New Monumental Arch

Memorial Avenue, Washington, DC

Approval of Final Site and Building Plans

United States Department of the Interior

Final Site Plan

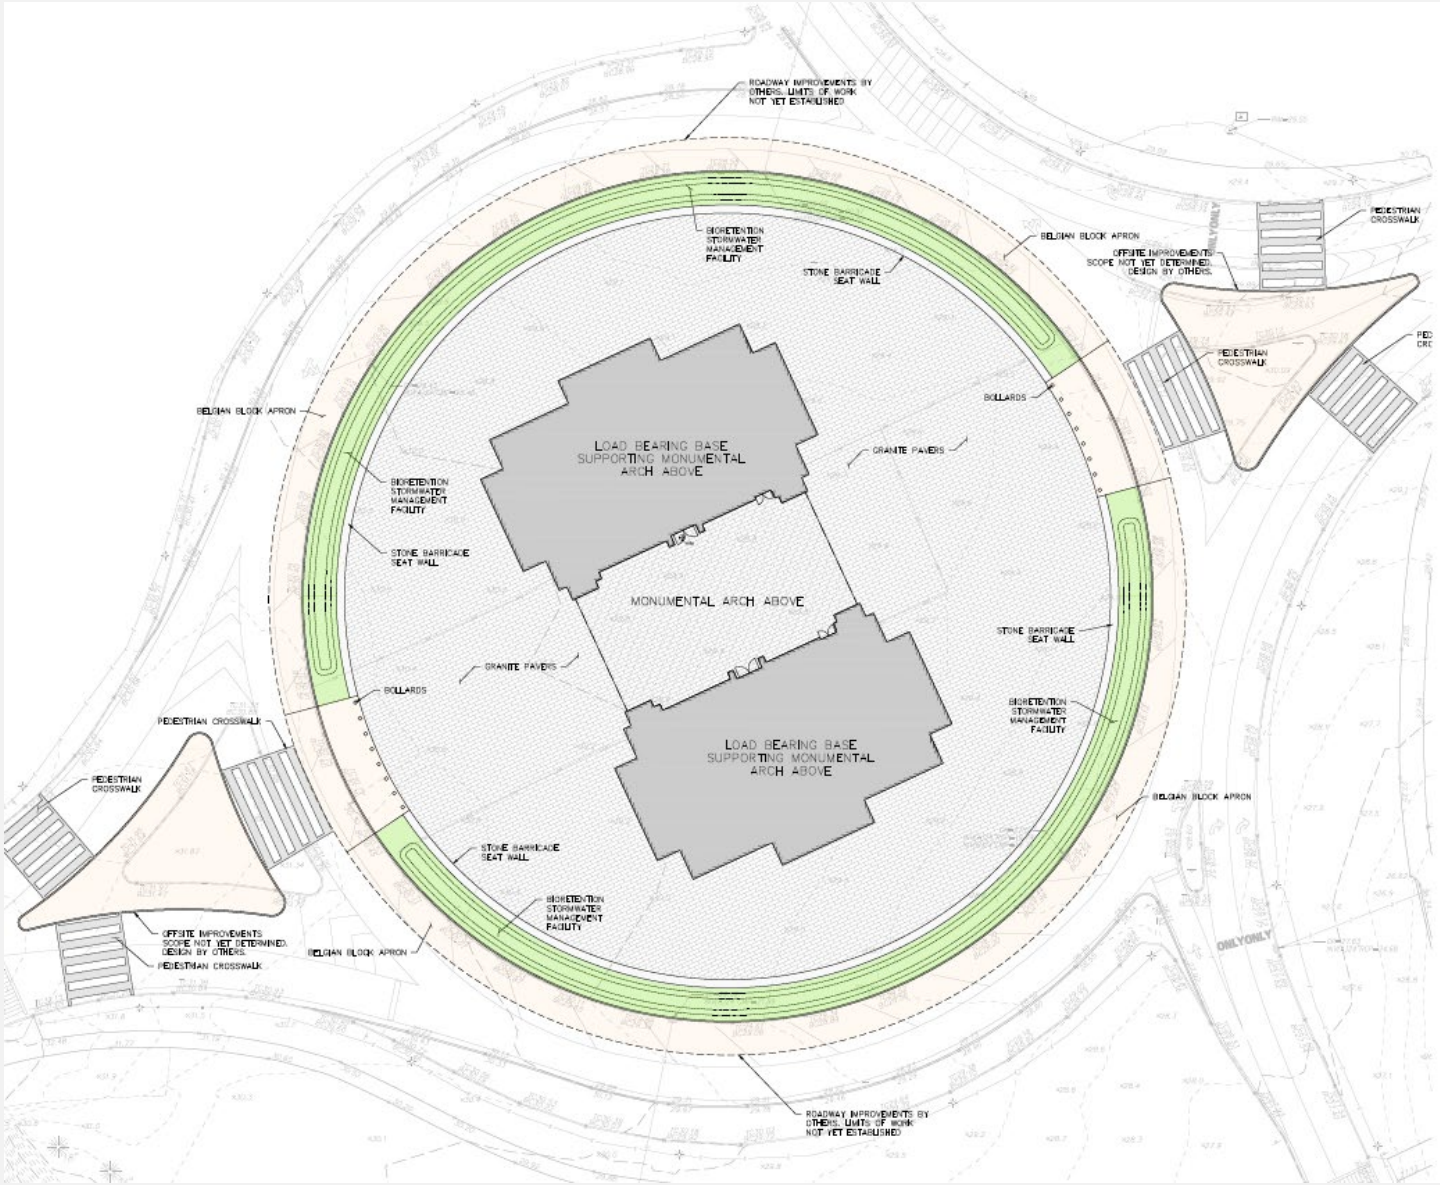
Final Updates:

- 15 Traffic Signals removed, 2 minimum maintained at each pedestrian crossing
- Recessed up-lighting removed

Traffic Signal Updates

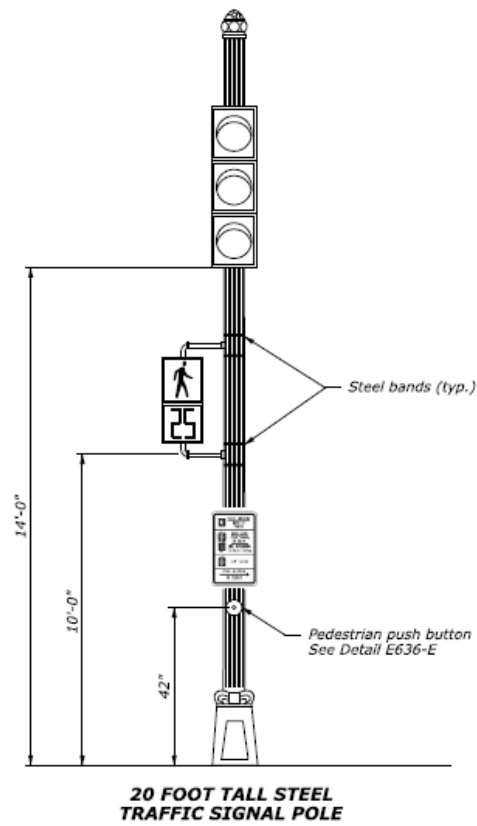
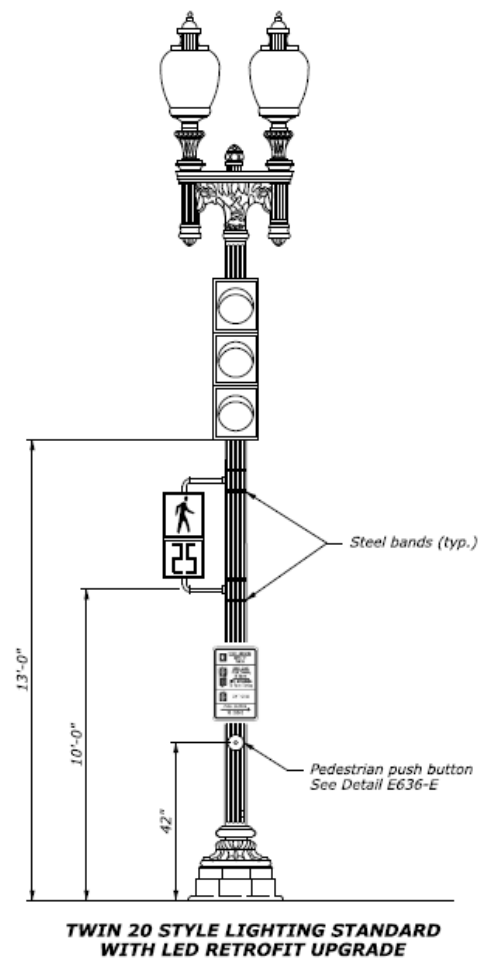
To reduce visual clutter within the landscape and provide a more representative estimate of the infrastructure required, an analysis was conducted to evaluate potential sight-distance and visibility constraints for each signal face. Based on this analysis, 15 traffic signal posts were eliminated from the preliminary design. Each signalized crosswalk will retain a minimum of two traffic signal posts and the necessary three-section vehicular signal indications, pedestrian signal indications, and accessible pedestrian push buttons.

Final FAA Lighting Plan

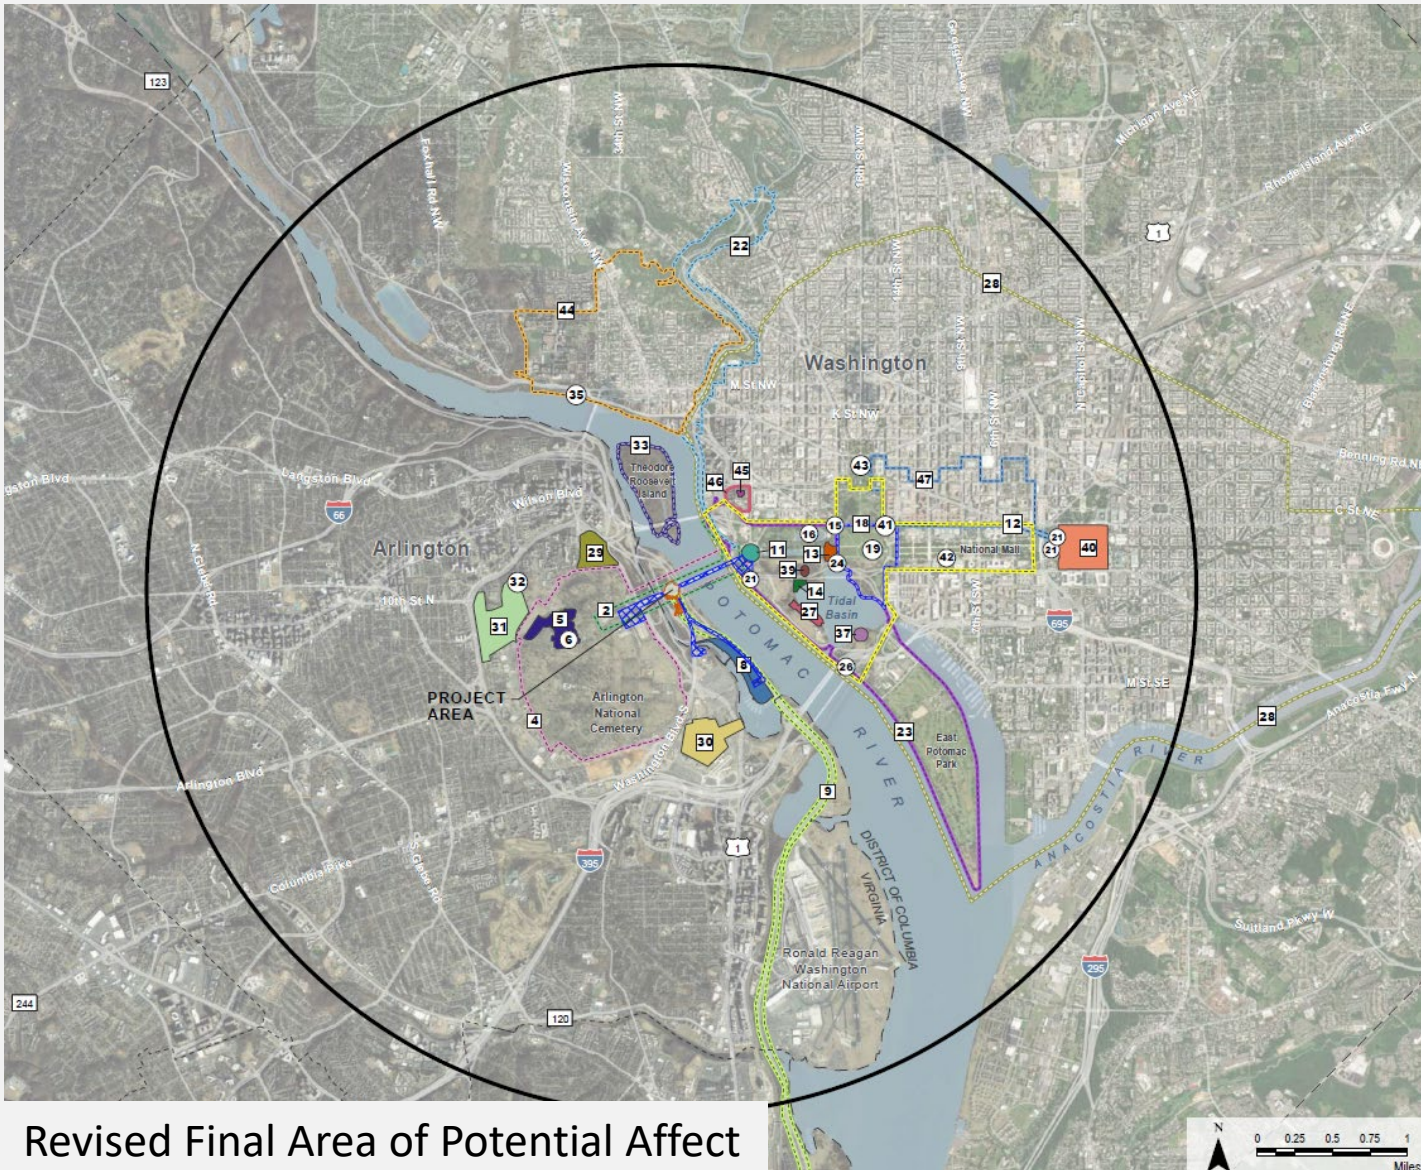
On September 18, 2026 the FAA provided NPS with a “DETERMINATION OF NO HAZARD TO AIR NAVIGATION” finding for the Triumphal Arch. Section 7, provides the following condition for safety lighting; *“The proposed structure should be appropriately marked/lighted with a non-standard eternal flame and continuously floodlighted by searchlight projectors installed at three or more equidistant points around the base of the structure. The searchlight projectors should provide an average illumination of at least 15 foot-candles (161.46 lux) over the top one-third of the structure, in accordance with FAA AC 70/7460-1N, Paragraph 4.5, to make it more conspicuous to airmen.”*
